**Application for an Order granting Development Consent for the proposed  
Hornsea Project Three Offshore Wind Farm**

**The Examining Authority's Deadline 6 – Responses on Orsted's comments to  
representation made by MCA at deadline 4.**

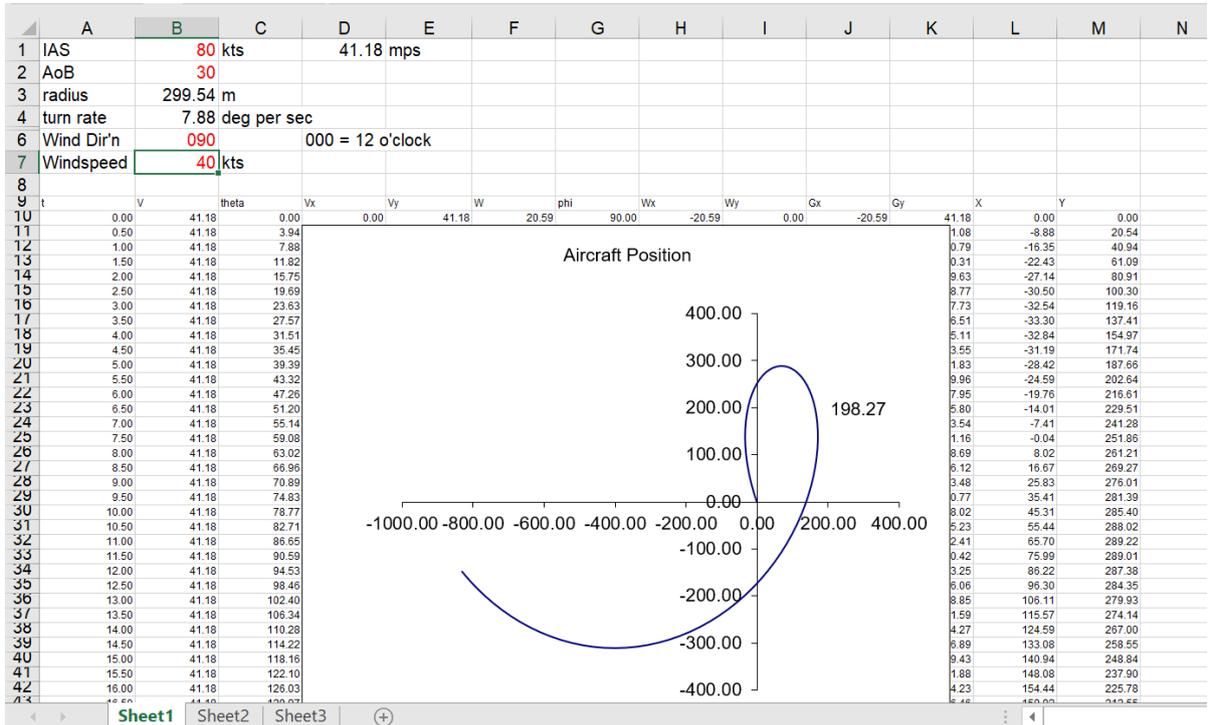
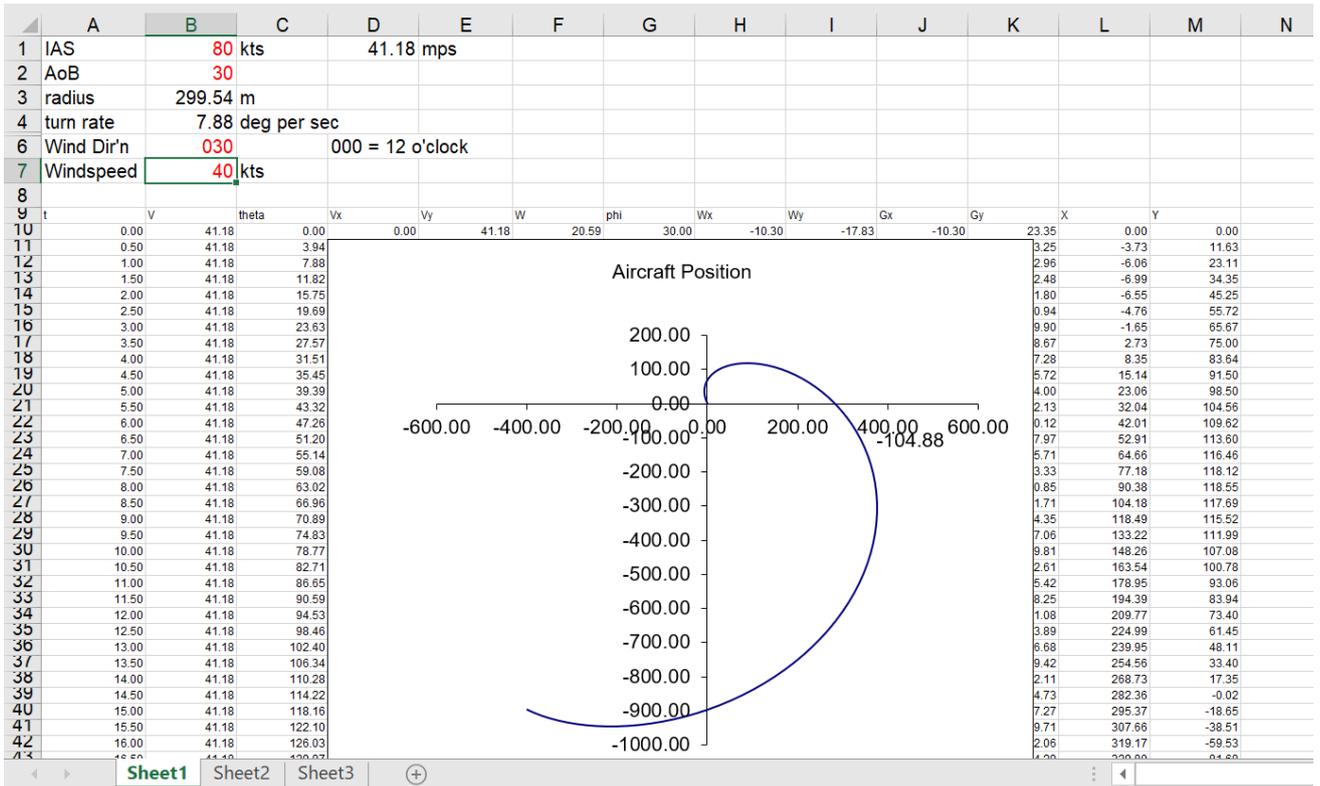
Reference to Q2.5.7 The Applicant would like to confirm whether the MCA agree that the Applicants technical evidence demonstrates that the helicopter can turn within 1km, if not, please can that evidence be provided?

As detailed in the “MCA report on renewables SAR trials” document, paper calculations (contained in 15 Aug meeting SAR follow-up v1.2) do not appear to have accounted for wind conditions or safety margins to turbines. When wind conditions are accounted for, particularly in higher values which may well be encountered during an incident, the turning radii is increased significantly. In a 40kt wind, a 30° angle of bank turn at 80 kts could result in a turning radius of up to 1km depending on wind direction. 150m of a safety margin is required for each turbine therefore 300m need to be added on. This is already in excess of 1km and should the windspeed increase, or a 20° angle of bank turn is conducted, the required space increases.

Also attached are two screenshots from a spreadsheet which calculates turning radius, created by a crewman working for the SAR helicopter provider. The MCA are not prepared to share this electronically but happy to show it to the Applicant if they want to discuss it further.
